ADDENDUM NO. 1

**EDGEMONT SCHOOL DISTRICT
GREENVILLE & SEELY PLACE SCHOOLS
HVAC UPGRADES AND CAFETERIA RENOVATIONS**

DATE: January 24, 2023

This Addendum consists of three (3) Pages, Sketch SK-A1.0, revised drawings GVES M200, GVES E101, SPES MD100, SPES M100, SPES M101, SPES M102, SPES M103, SPES M104, SPES M200, SPES M203, SPES M300, SPES M400, SPES ER100, SPES ER104, SPES E100, SPES E103, and SPES E104.

DRAWING NO.
SPES
E100
FILE NO.
21434.01

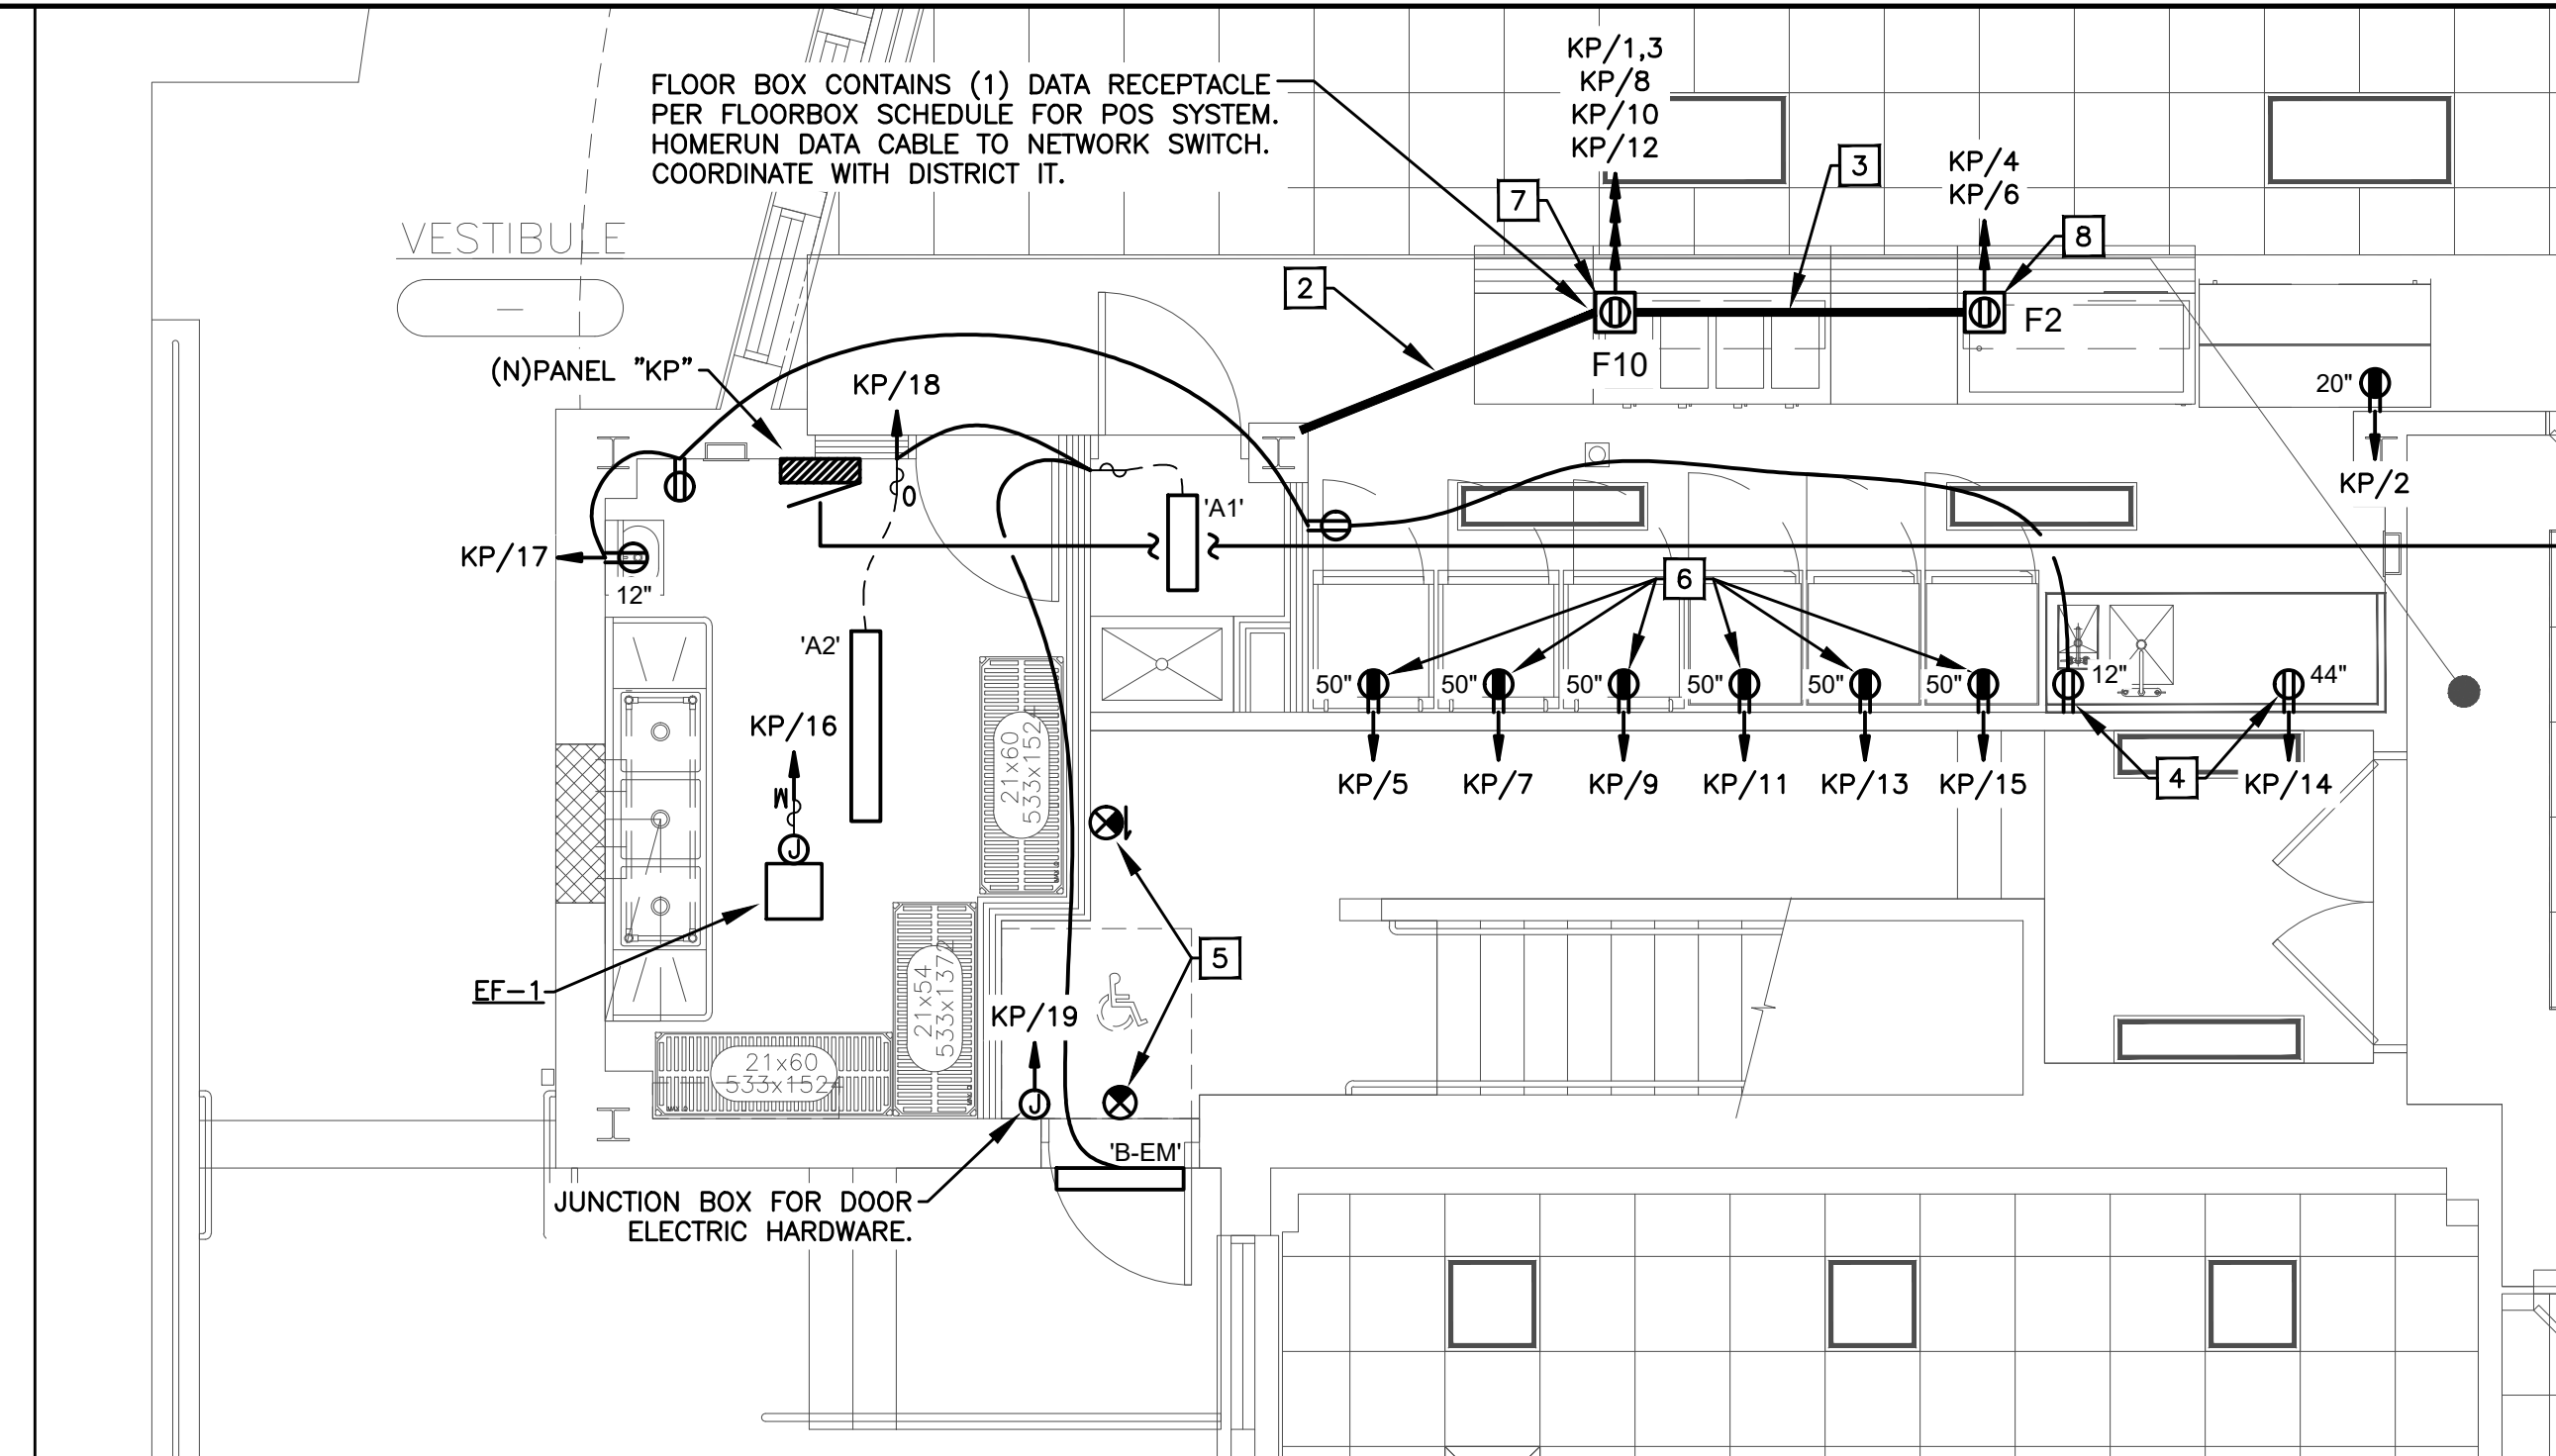
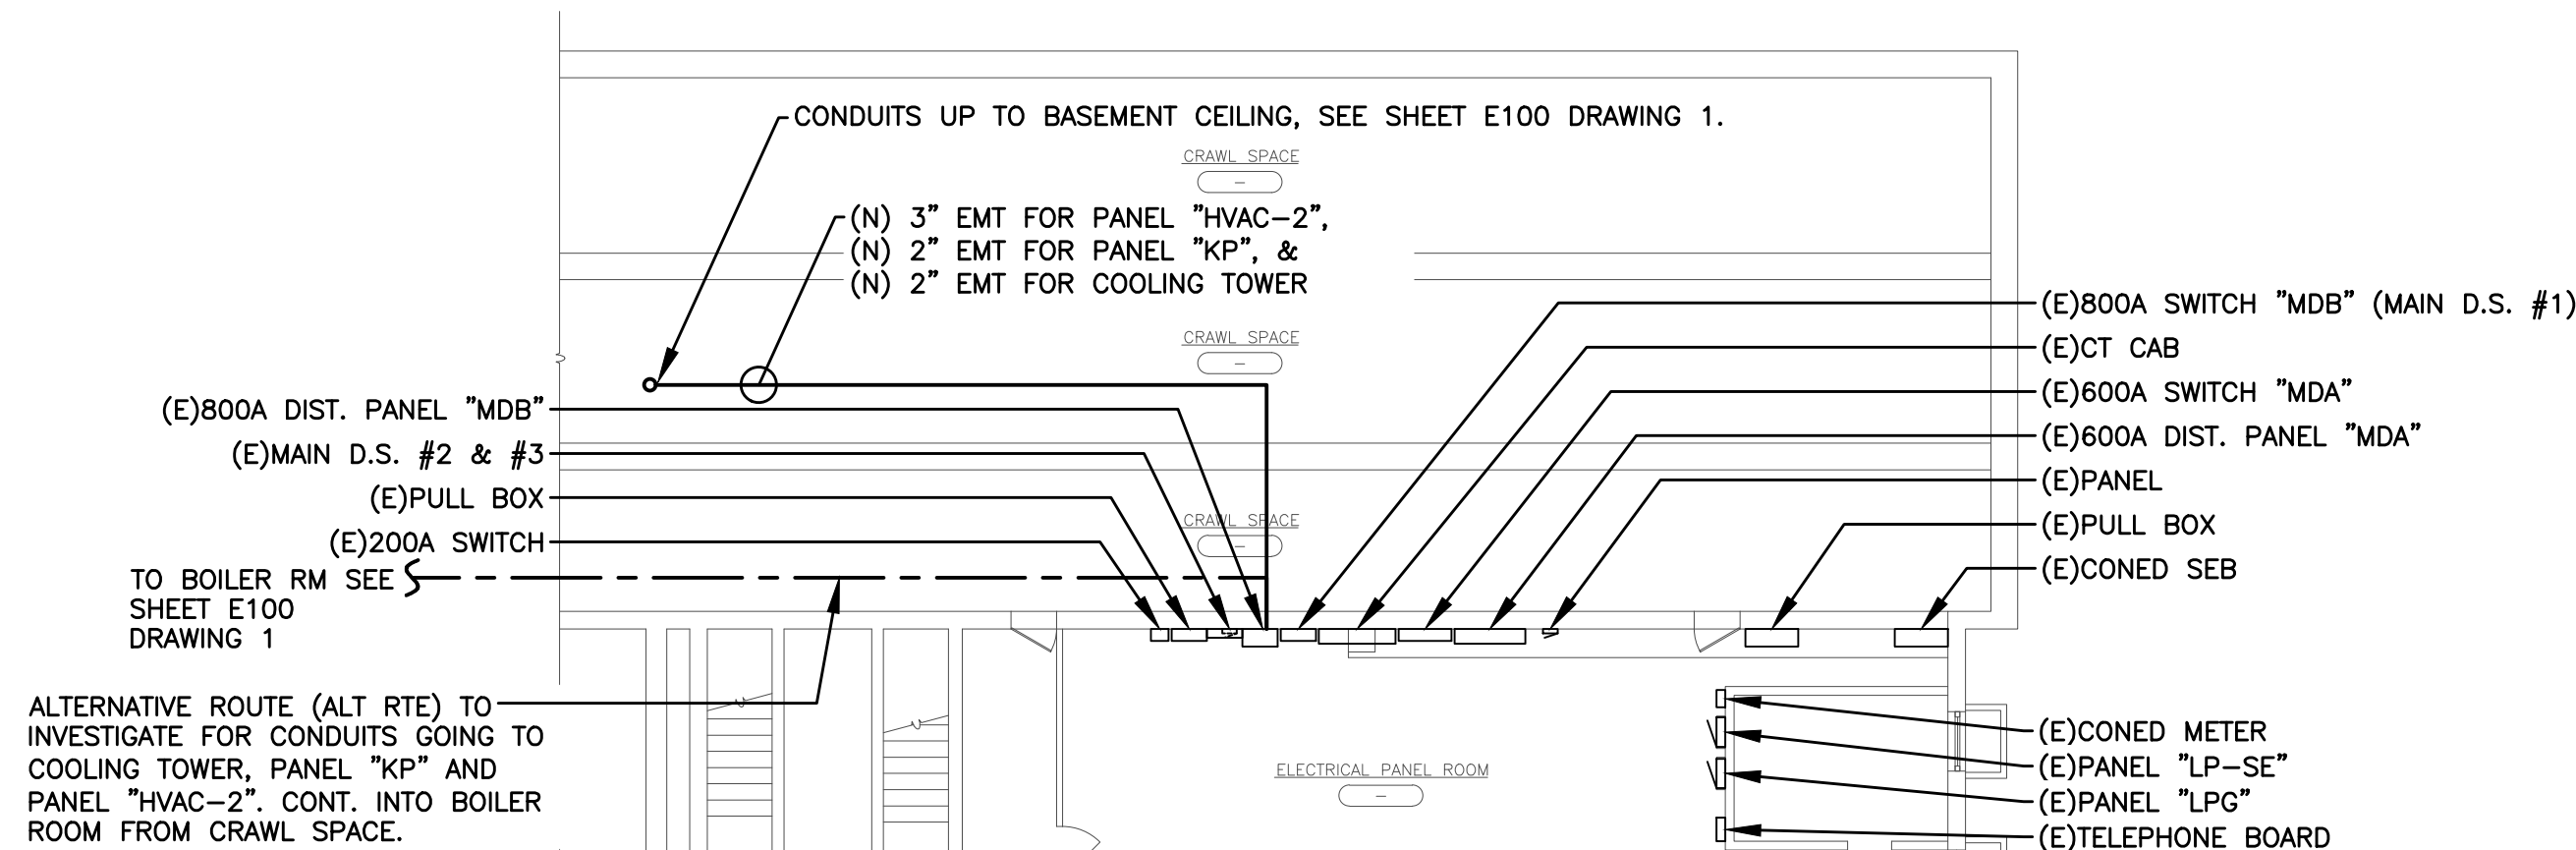
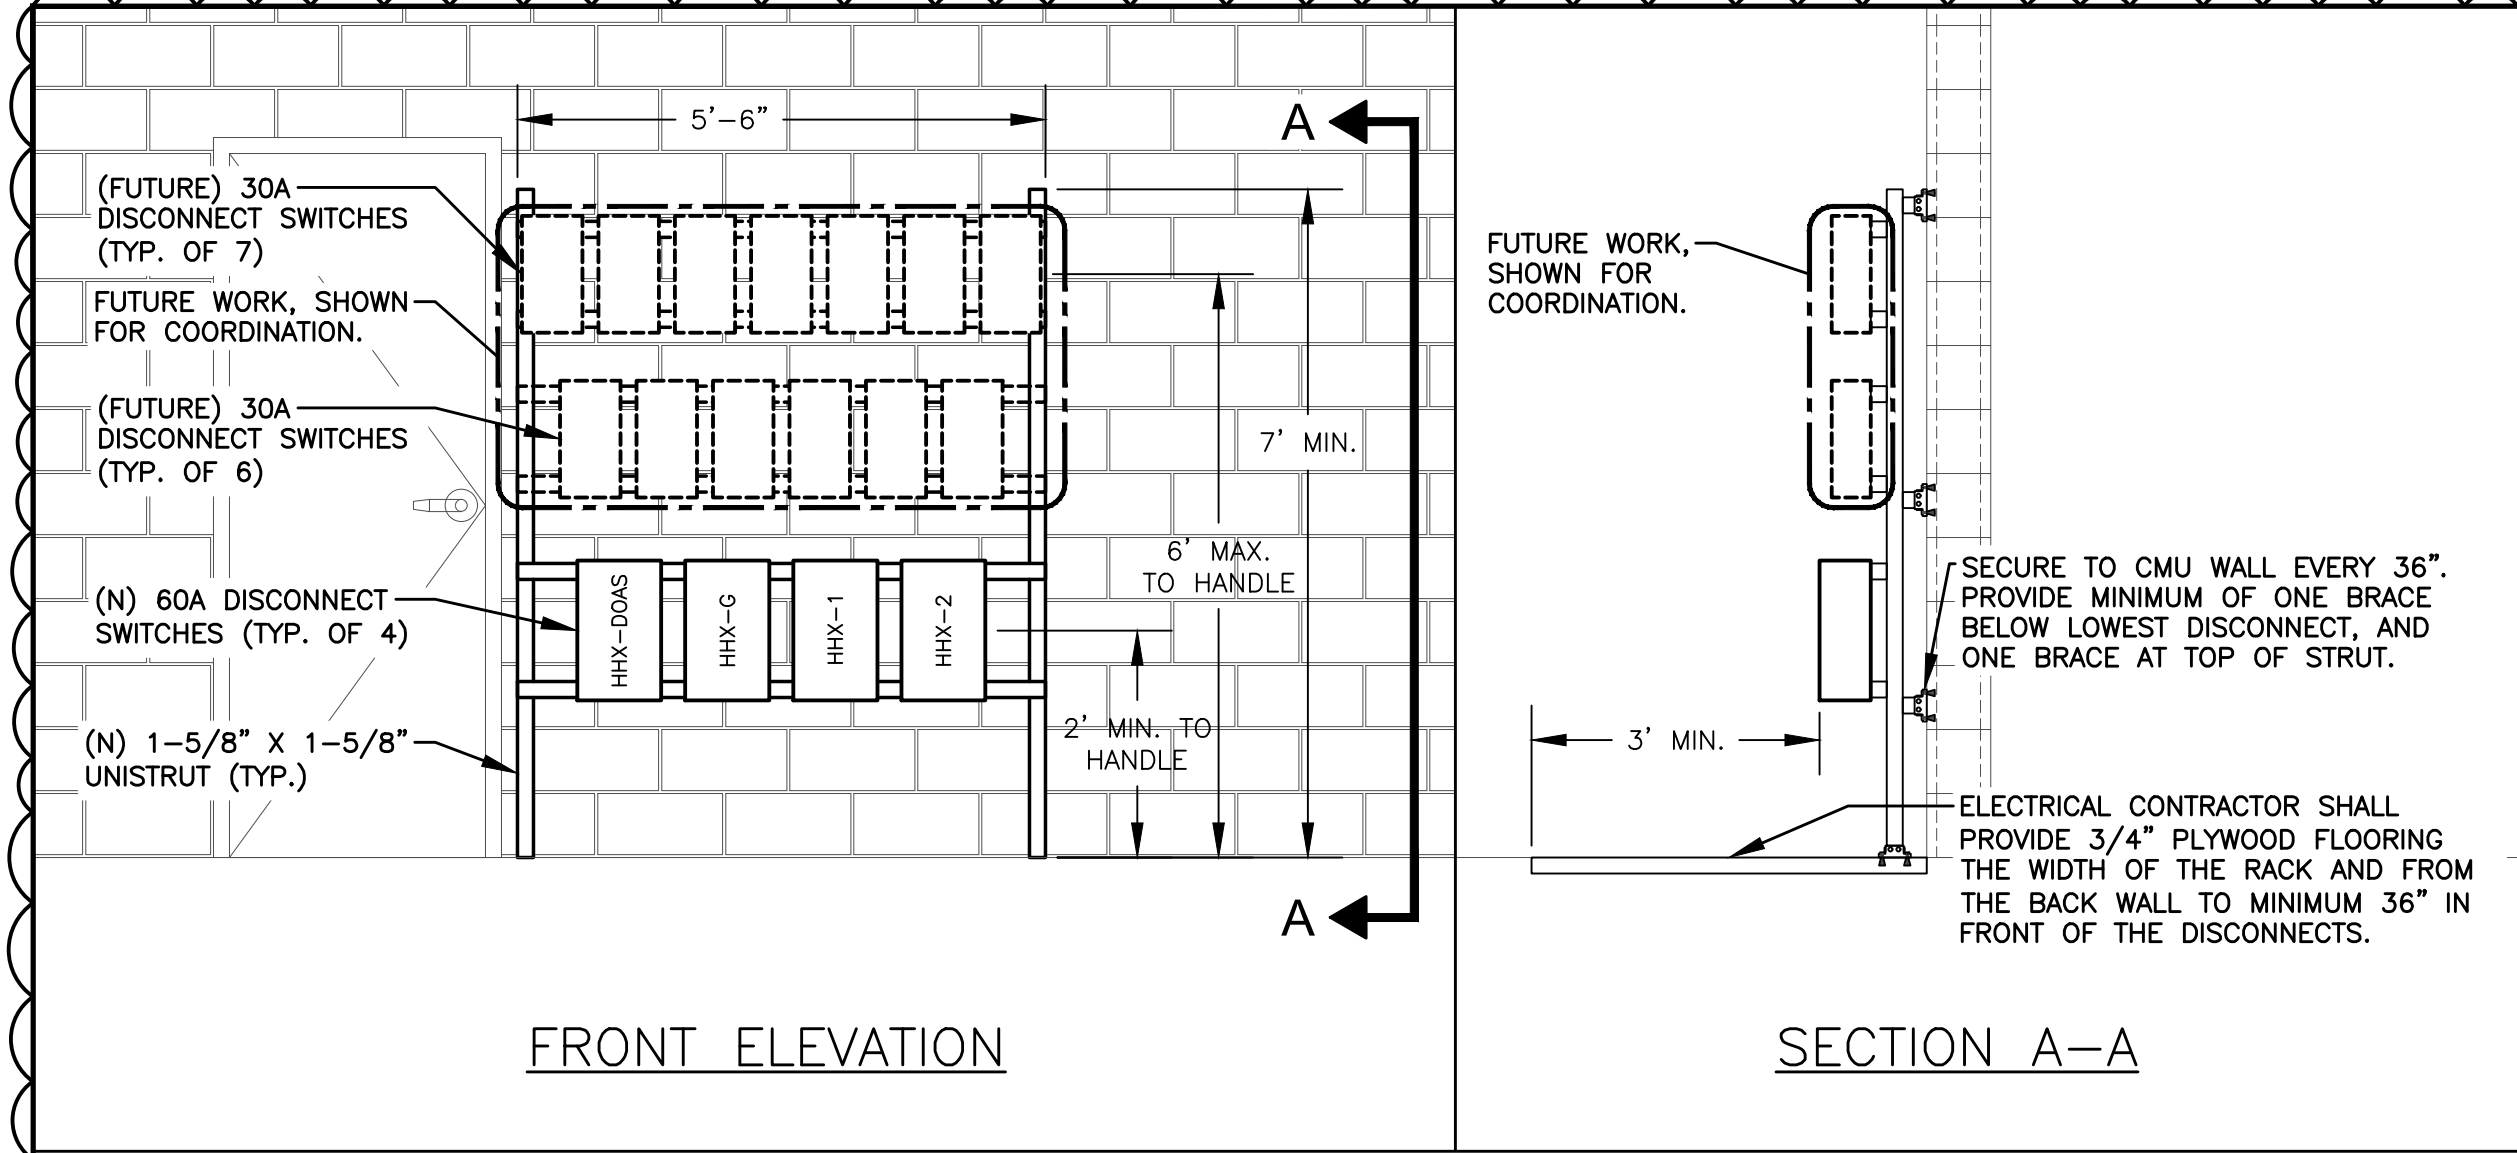
DRAWING SPES E100 – BASEMENT AND SUB-BASEMENT ELECTRICAL PLAN

REVISE general note #2 as shown on drawing attached to this addendum.
